REVISION TRANSMITTAL

This sheet transmits Revision 1 to SL560XL-53-19, which:

FUSELAGE - EMPENNAGE FASTENER VERIFICATION

SL560XL-53-19
Page 1 of 8

Figure 1. Rivet Inspection/Replacement (Sheet 1)

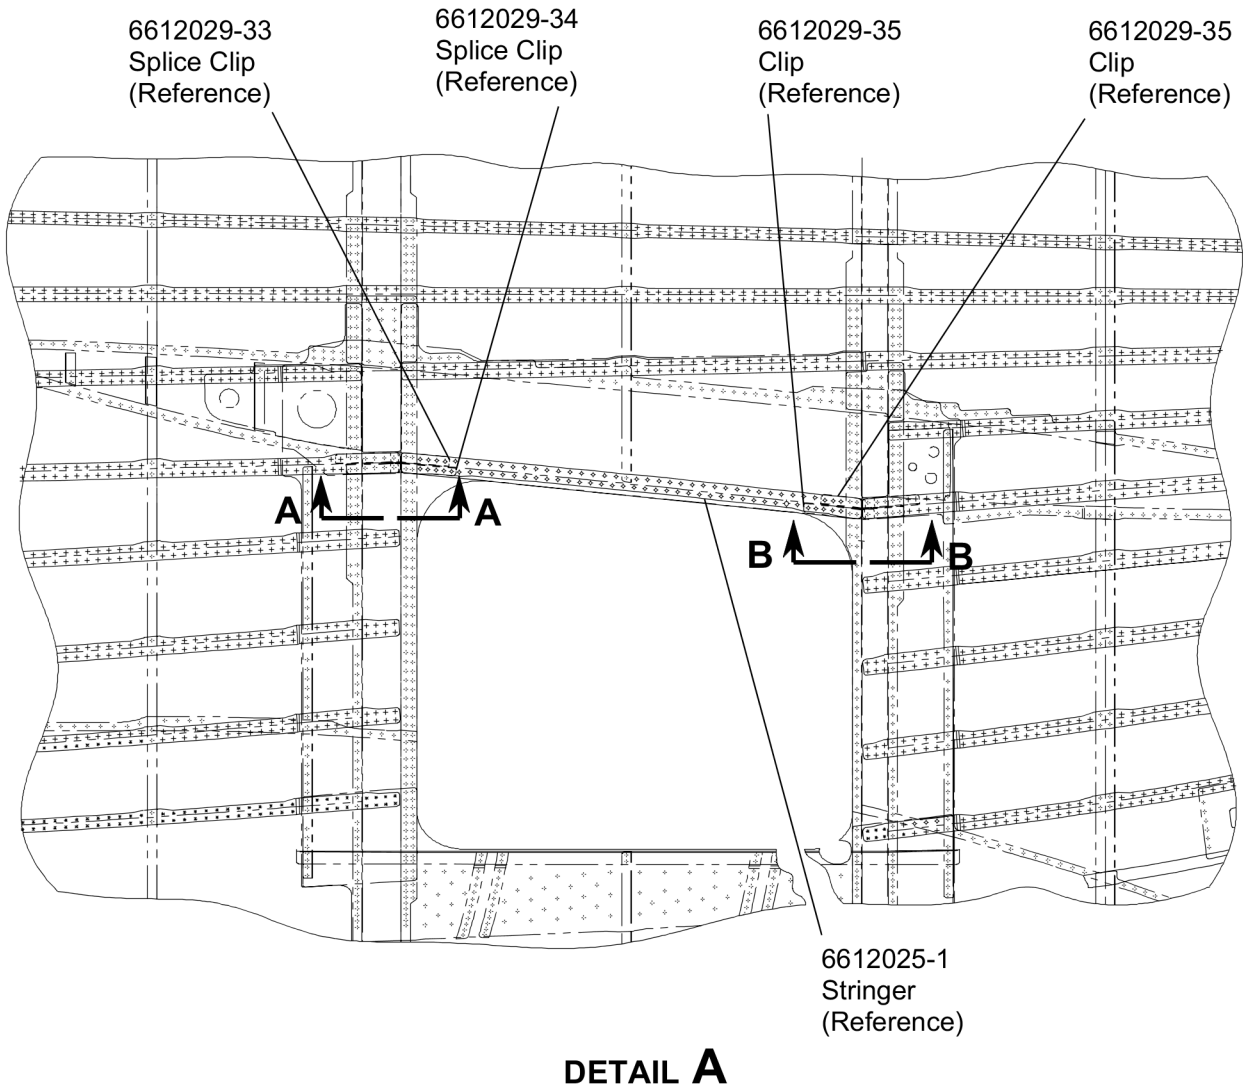
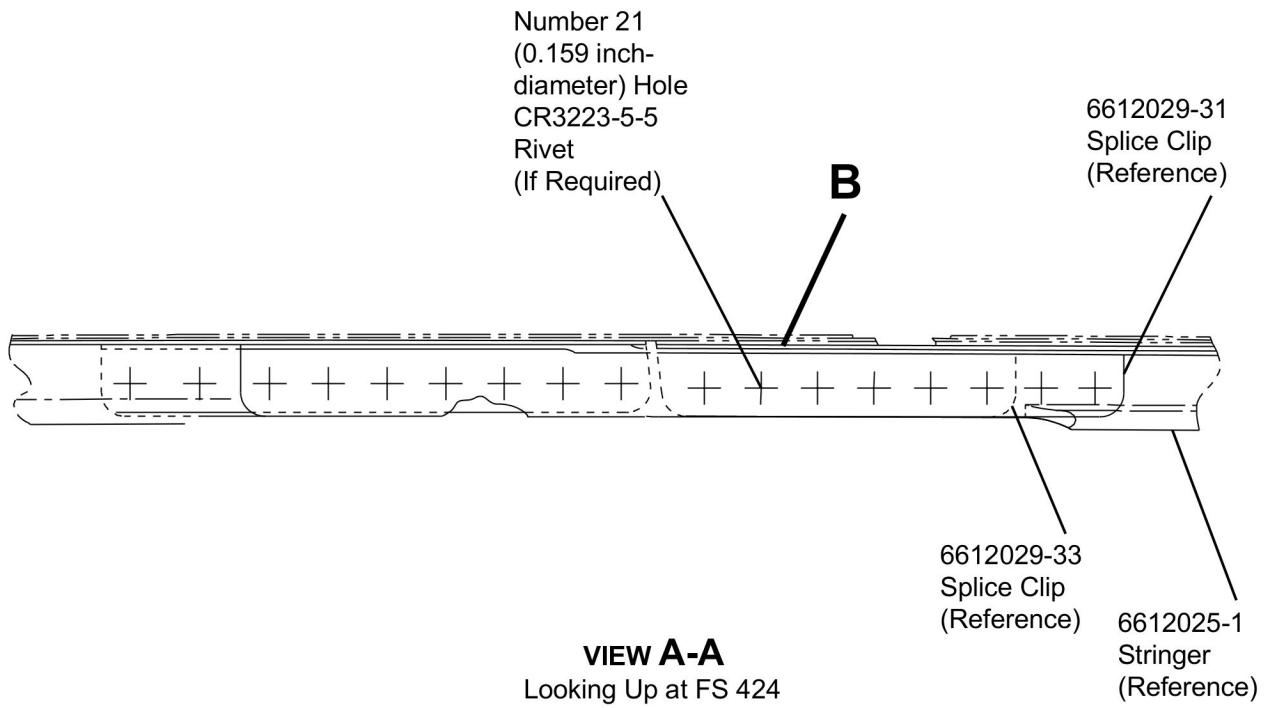
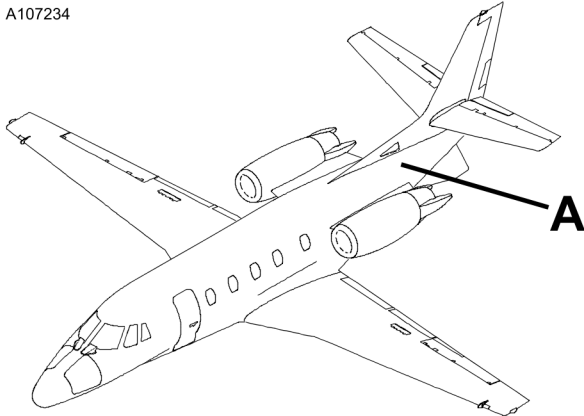
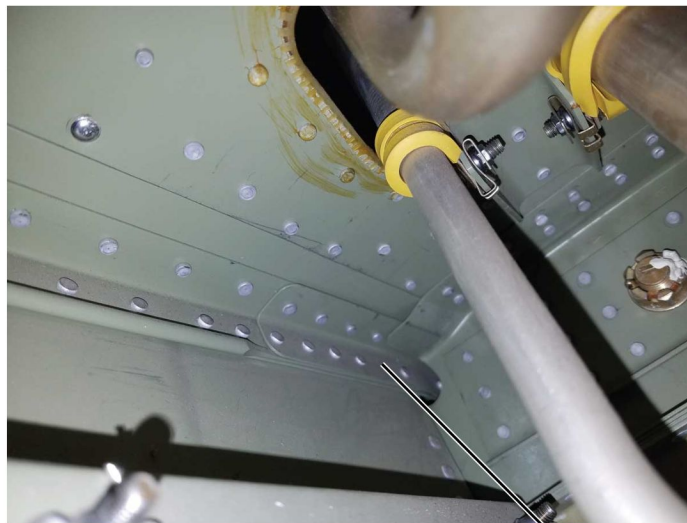
- B. (Refer to Figure 1, Detail A, View A-A and Detail B.) Inspect the rivets at FS 424 common to the 6612025-1 Stringer, 6612067-3 Longerons, 6612029-33 Clip and 6612029-34 Clip.

CAUTION: The fastener must be located a minimum of 1.0 inch from the F.S. 424 Frame to avoid drilling into the edge of the 6612067-12 Bracket.

Figure 1. Rivet Inspection/Replacement (Sheet 2)

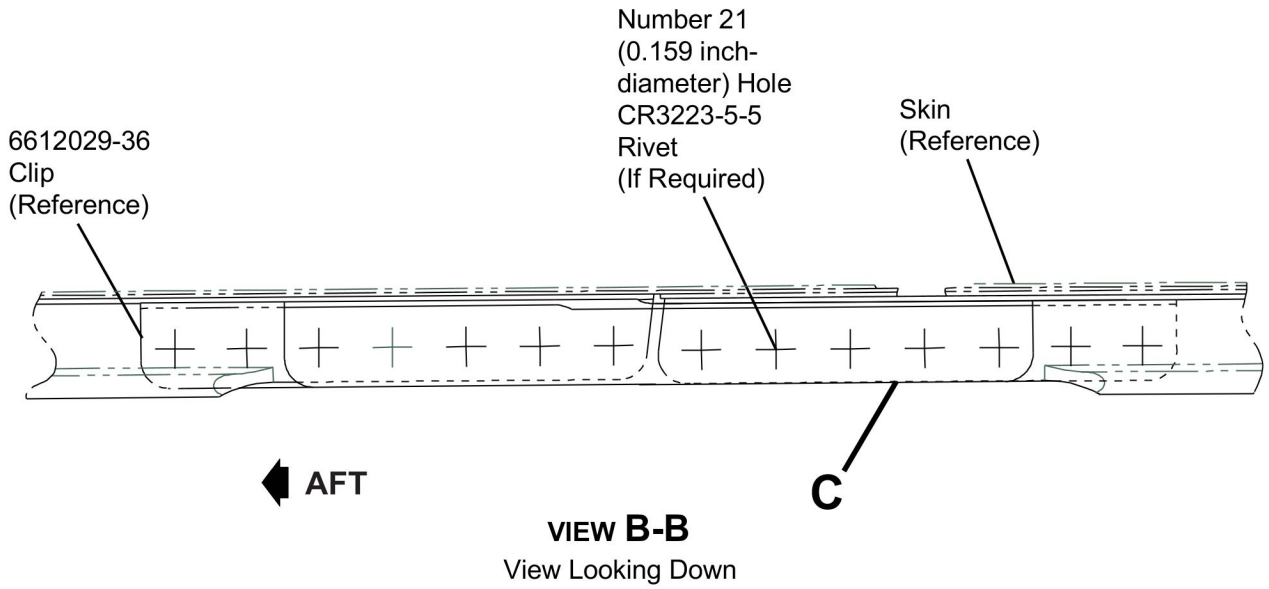
- A. Changes the hole size drilled from Number 30 (0.128 inch-diameter) to Number 21 (0.159 inch-diameter) in Step 2.B.(1).(a).1 and Step 2.C.(2).(a).
- B. Changes Figure 1, Sheet 2 and Sheet 3 to show the correct hole size to be drilled.
- C. Adds a CAUTION to Step 2.B.(1).(a) that the new hole must be located a minimum of 1.0 inch from the F.S. 424 Frame.
- D. Adds a CAUTION to Step 2.C.(2) that the new hole must be located a minimum of 1.0 forward of the F.S. 460 Frame.

DETAIL B

Location of possible missing rivet

1 (Refer to Figure 1, View A-A and Detail B.) Layout and drill one Number 21 (0.159 inch-diameter) hole in the 6612025-1 Stringer, 6612067-3 Longerons, 6612029-33 Clip and 6612029-34 Clip at the location shown.
